Recall Campaign Bulletin

Campaign No. 2022090011, November 2022

SUBJECT: **Model C-Class Sedan (206 platform)**
Model Year 2022

Retrofit a Cover for the Rear SAM

Figure 1

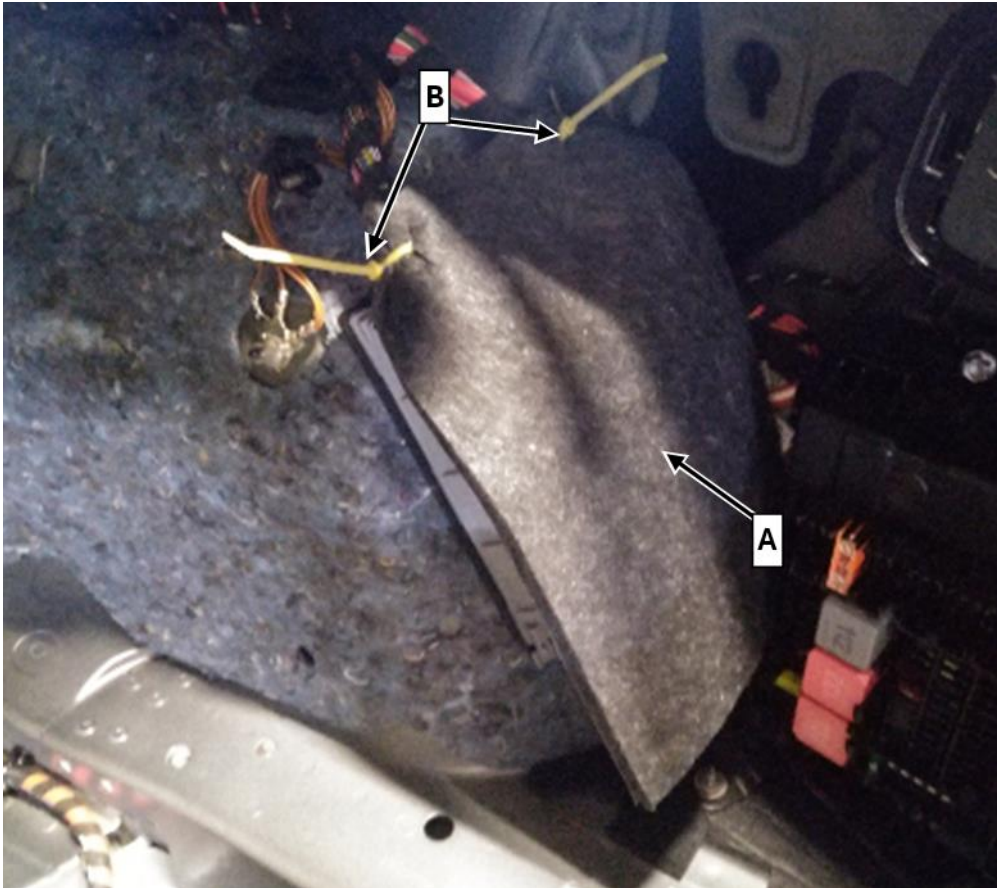
1. Loosen rear right trunk lining and fold inward.
2. Retrofit felt (A, figure 1)
 - i** To do this, dispose of the 2 clips from the new felt and attach two cable ties (B, figure 1) to both electric lines.
 - i** The grey smooth side has to face against the control unit.

3. Shorten protrusion of the cable tie.
 4. Assemble in reverse order.
-
